CITY OF BERKLEY, MICHIGAN REGULAR MEETING OF THE CITY PLANNING COMMISSION

Tuesday, April 26, 2022
7:00PM – City Hall Council Chambers
Information: 248-658-3320

3. **PSP-04-21: Lot 53 on Oxford Road – The Ivy:** Site Plan for Phase II of the approved project at 2219 Coolidge for the removal of the existing parking lot and construction of two multiple family buildings with a total of 24 dwelling units and a parking lot.
4. **PSP-05-22: 2576 Coolidge Highway – BP America:** Site Plan for a new canopy, parking reconfiguration, pump island reconfiguration, new landscaping and building façade improvements of the existing gasoline station.

C-7

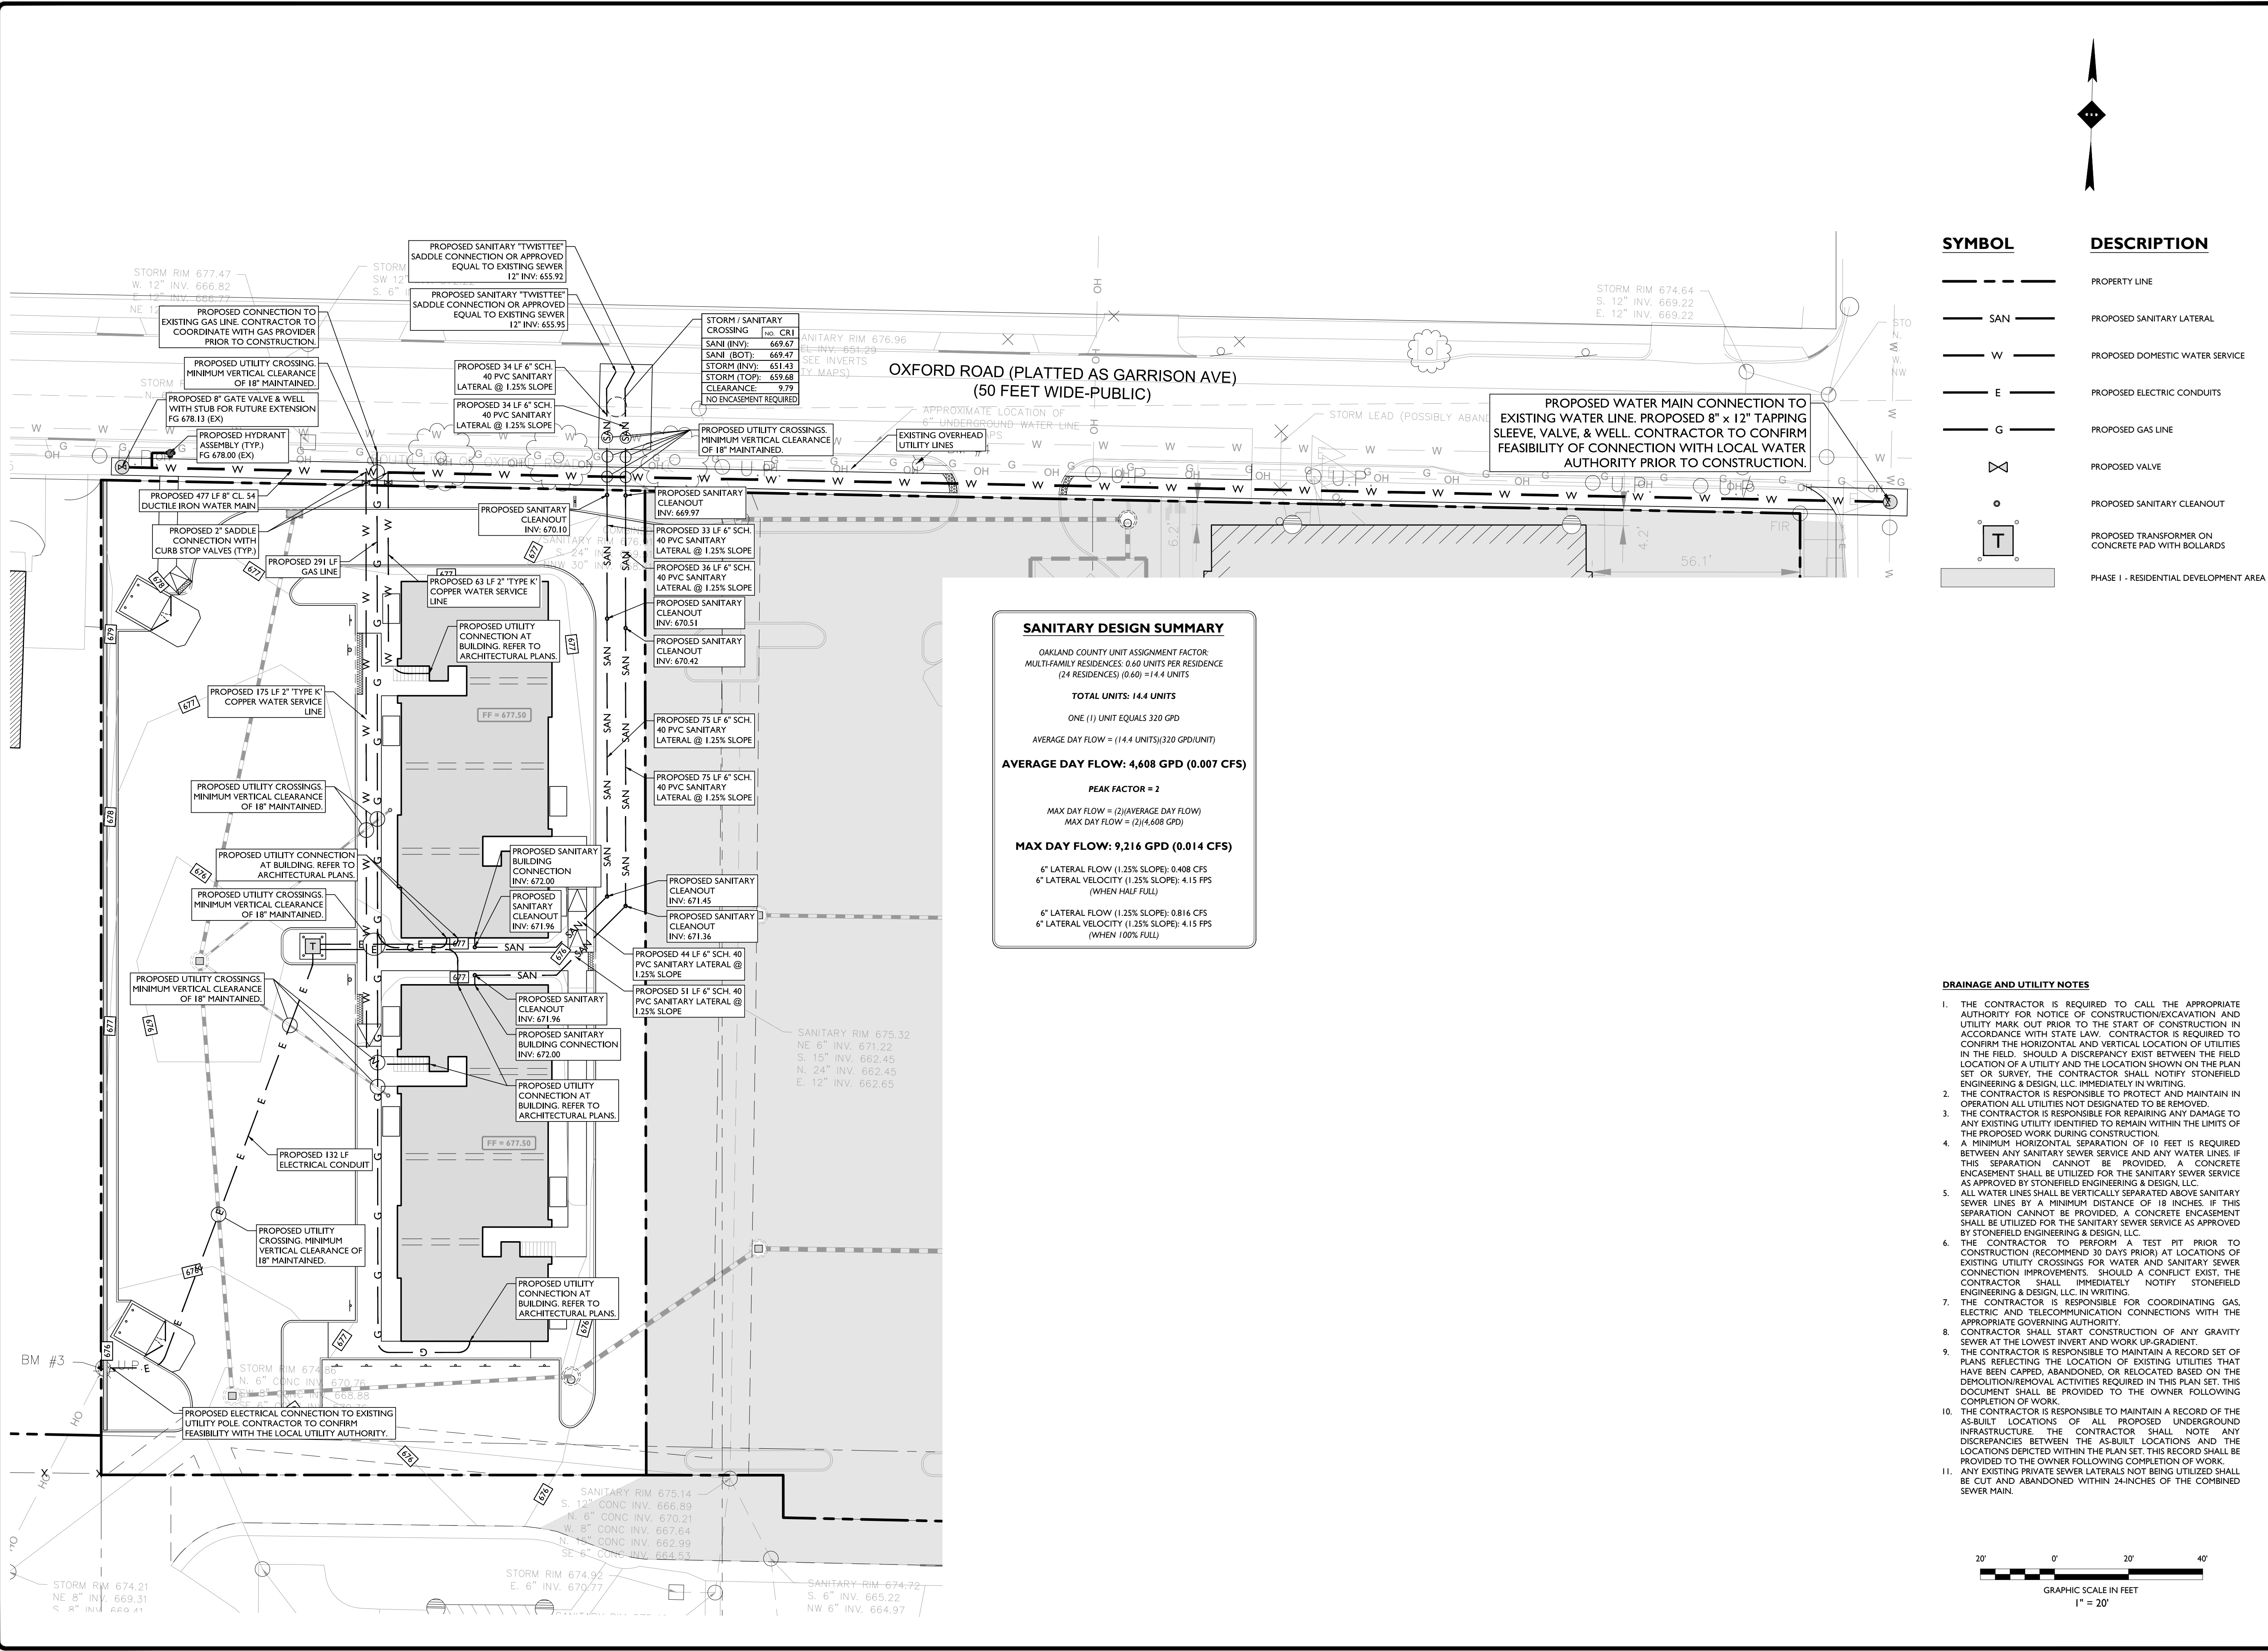
5. The applicant will need to demonstrate that the downstream sewer has the capacity to support the development and new sanitary flow. Calculations for both existing verification and the new 6" lines shall be shown on sheet C-7.

3. Please incorporate the attached City of Berkley Material Specifications to sheet C-7.
4. A traffic control plan shall be added to the plan set to account for the proposed work on both Coolidge and on Oxford.

Sanitary laterals have been revised to wye into the public sewer across Oxford as noted. See Sheet C-7 of the Site Development Plans.

Sanitary basis of design for the new 6" laterals have been provided on Sheet C-7 as requested.

Water main revised to be 8" CL. 54 D.I.P. as requested. See Sheet C-7.

New hydrant has been relocated per conversations with DPW. See Sheet C-7.

Proposed water main has been revised to be 8" CL. 54 D.I.P. See Sheet C-7.

REU calculations have been included as requested. See Sheet C-7.

Sewer laterals revised to connect into existing combined sewer across Oxford Road. See Sheet C-7.

Proposed sanitary connections have been labeled as “TwisTee” sewer saddles as required. See Sheet C-7.

DRAWING: C-5

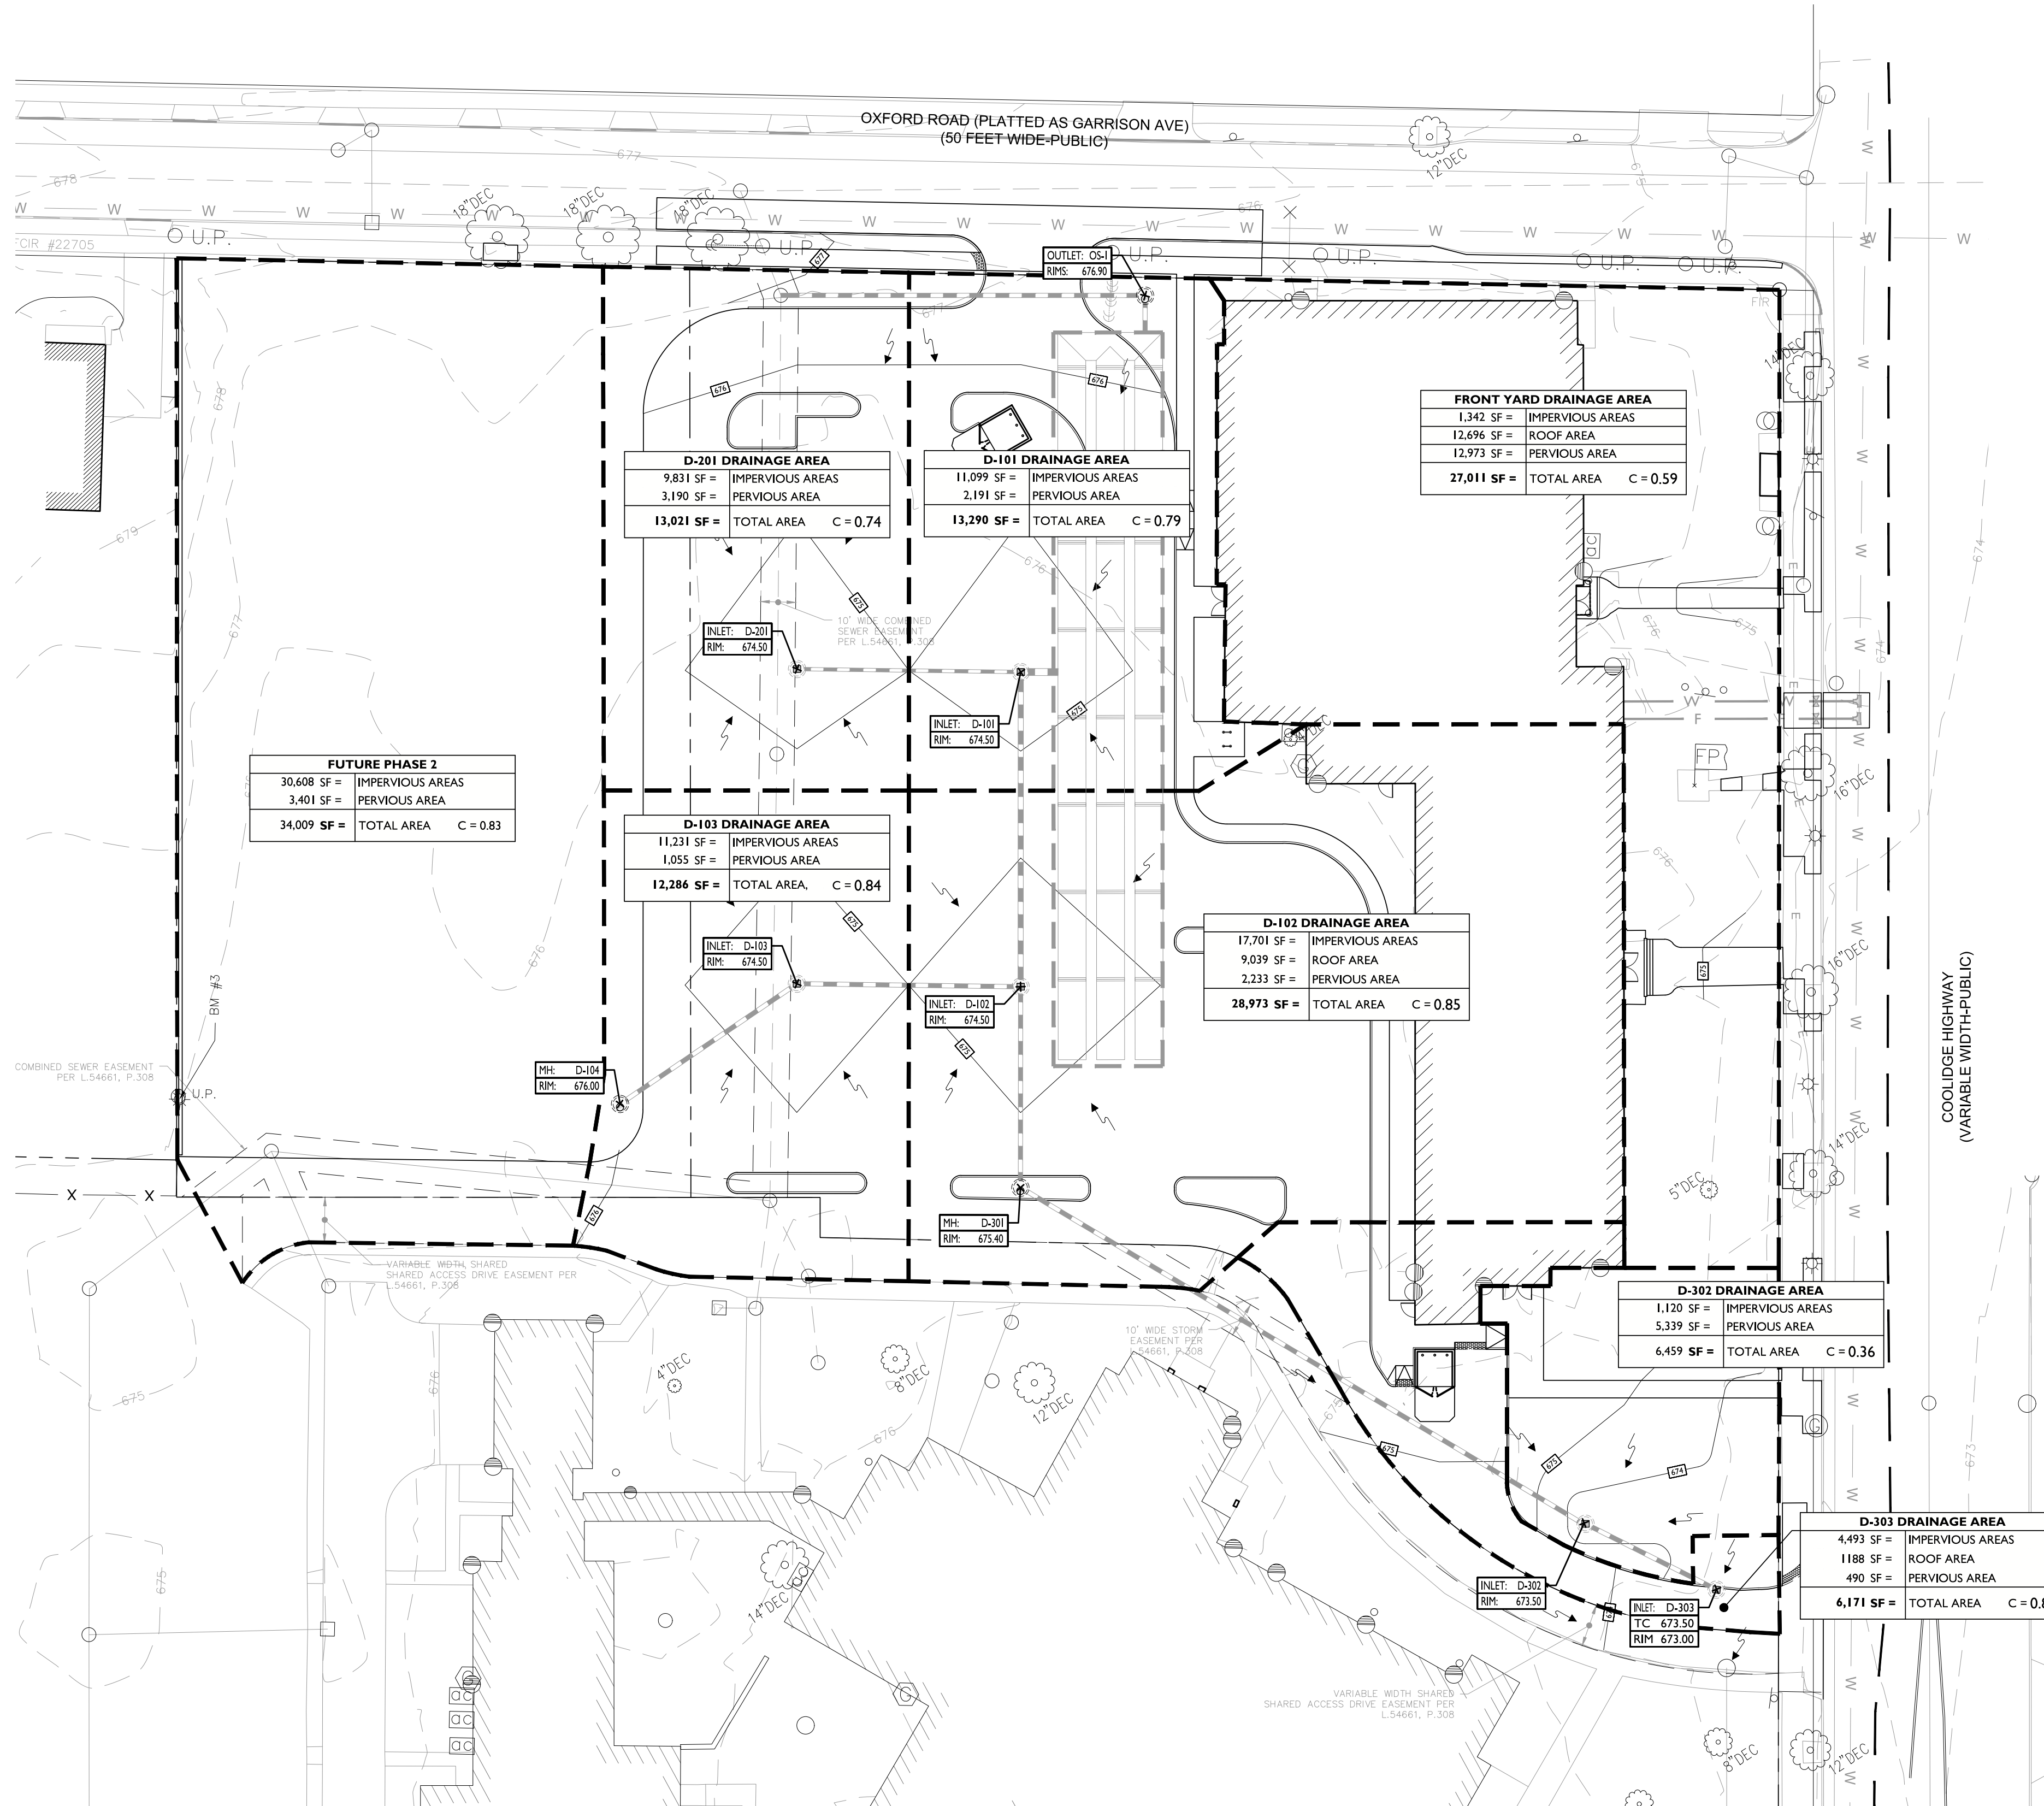
6. Please note the proposed stormwater management system will be a private system under the maintenance of the property owner. The stormwater management plan (sheet C-6) shall clarify if the Ivy Apartments are covered under the agreement for "The Berkley" or if a separate document is required.

The existing Storm Agreement will be amended to include "The Ivy" conveyance system. See revised exhibits for review.
